ADDENDUM NO. 2

BID NO. 2838

**CLOVIS EAST HIGH SCHOOL CTE FARM AND FOOD PRODUCT FACILITY
CLOVIS UNIFIED SCHOOL DISTRICT
CLOVIS, CALIFORNIA**

G.A. PROJECT NO. 1739

AD-1

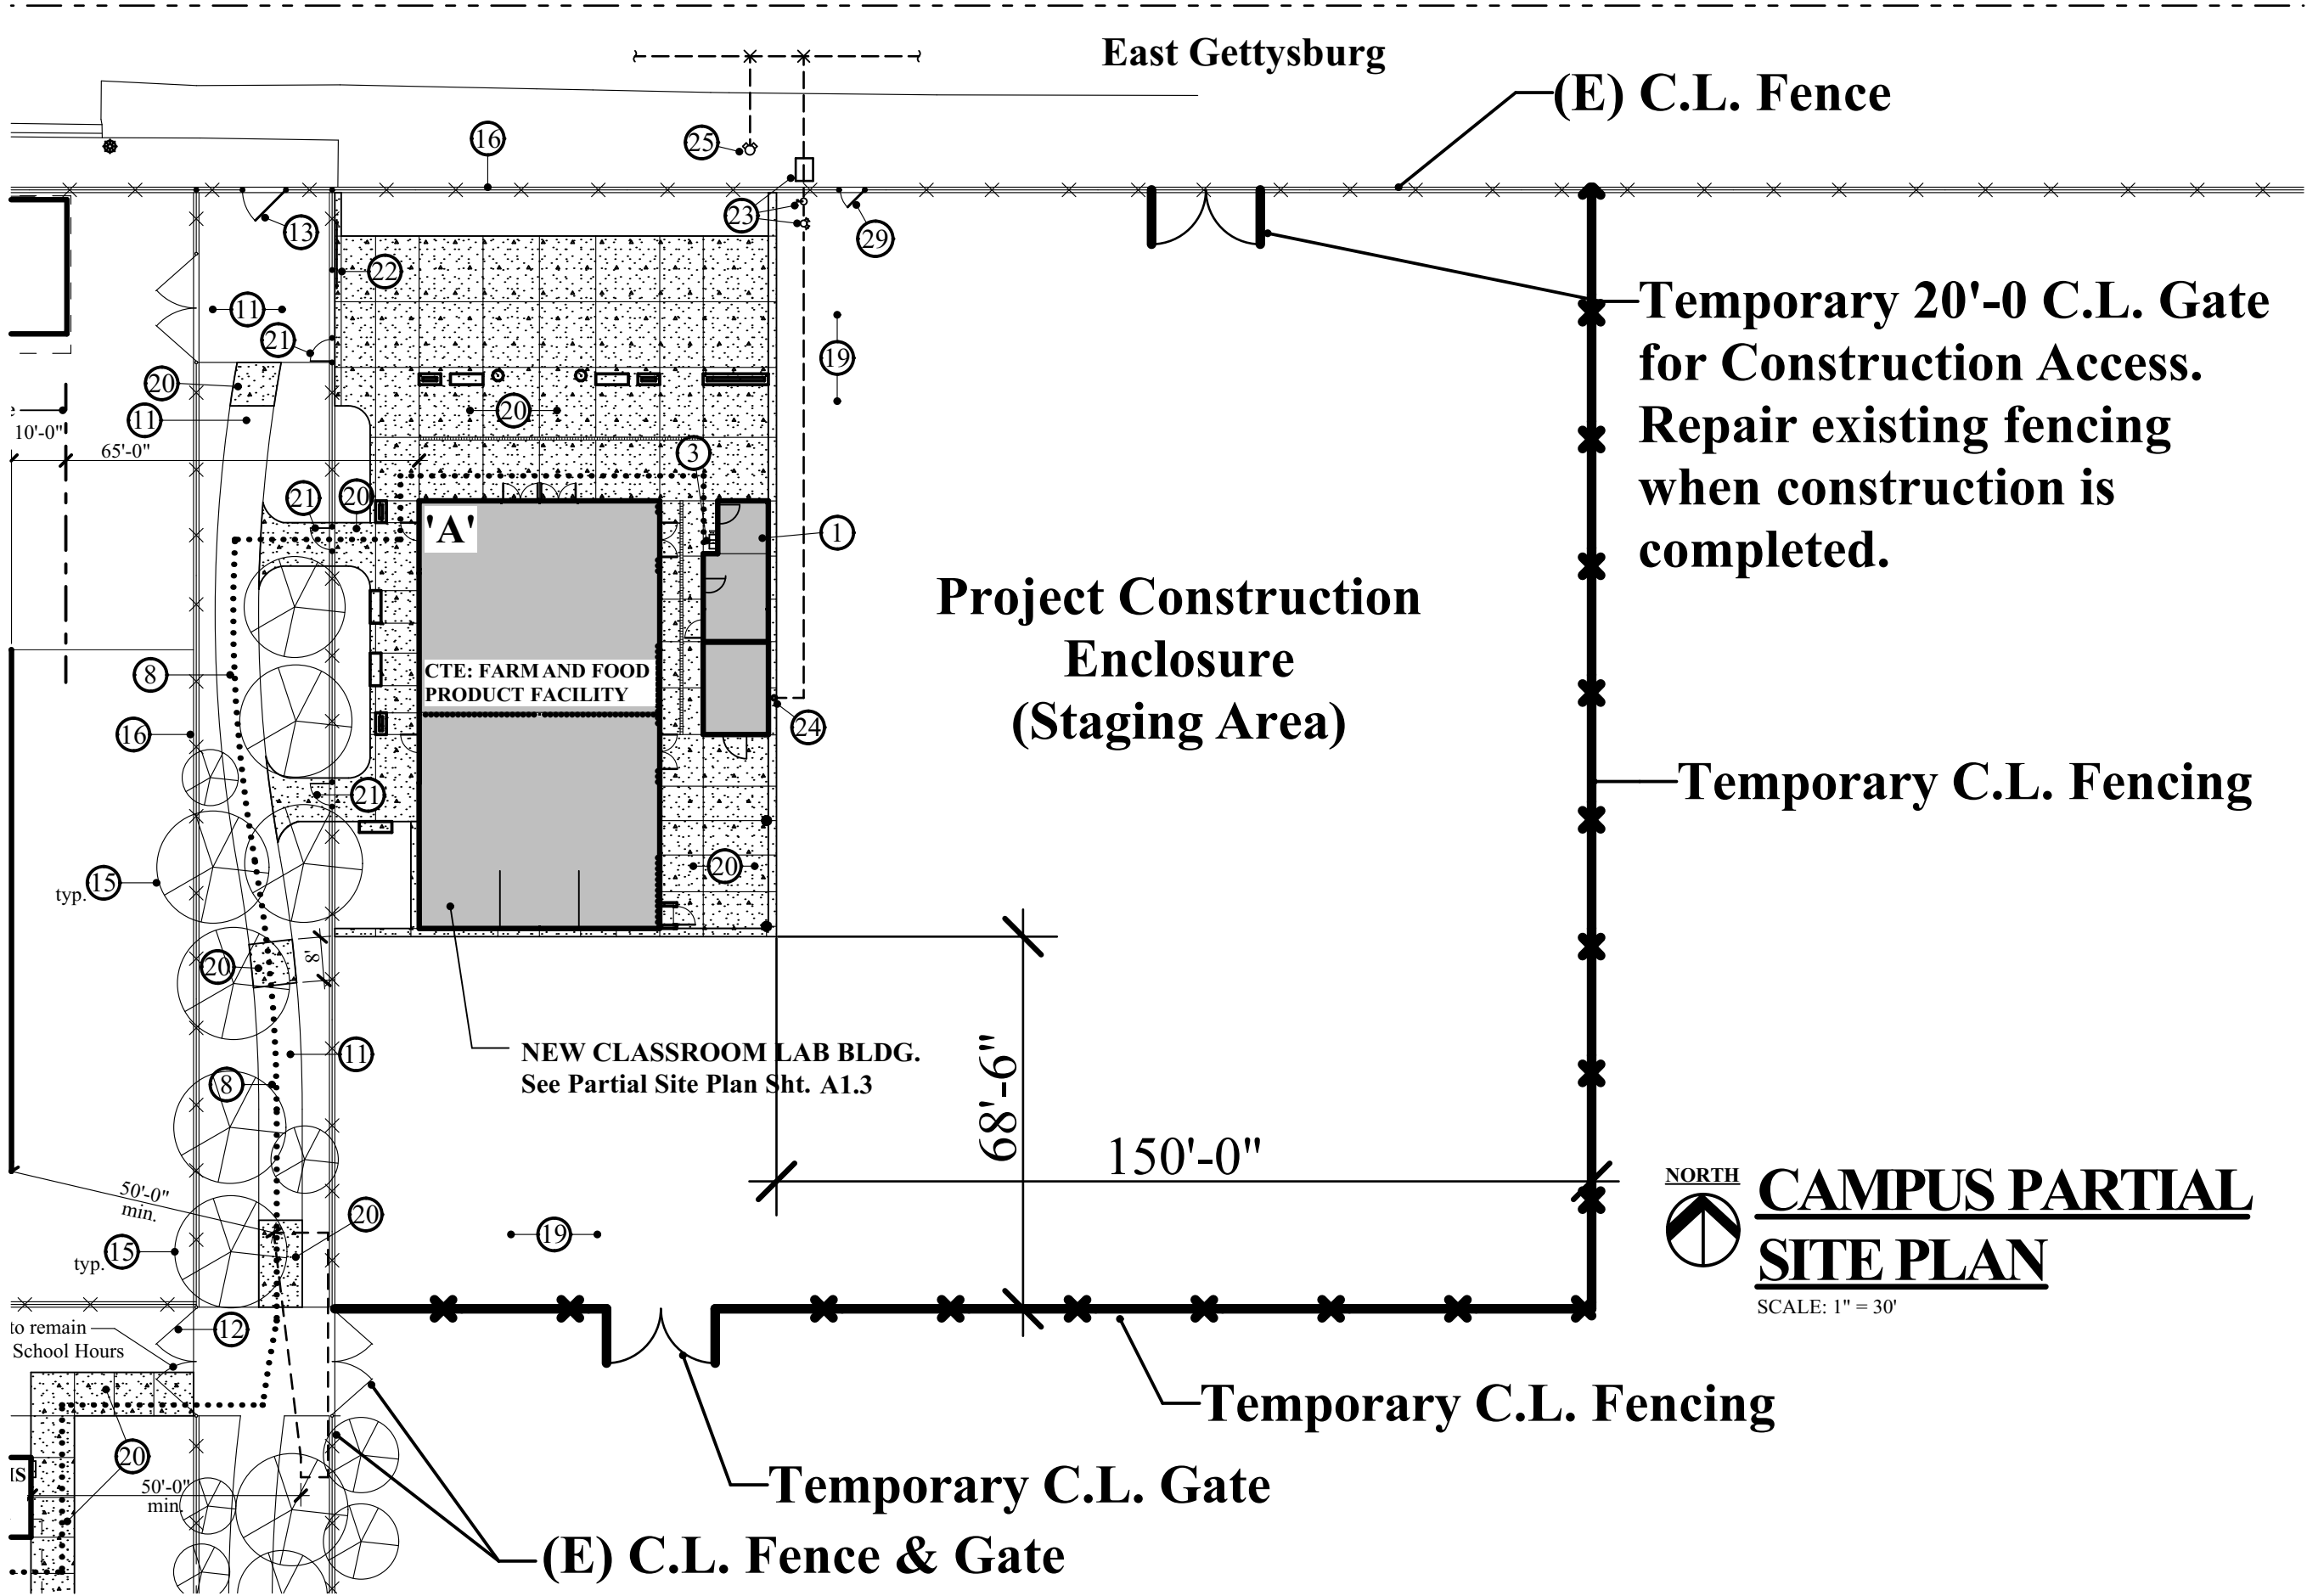
5. PROJECT CONSTRUCTION ENCLOSURE:
Refer to attached drawing AD-1 Staging Area

A temporary project enclosure shall be provided; see attached drawing AD-1 Staging Area for requirements.
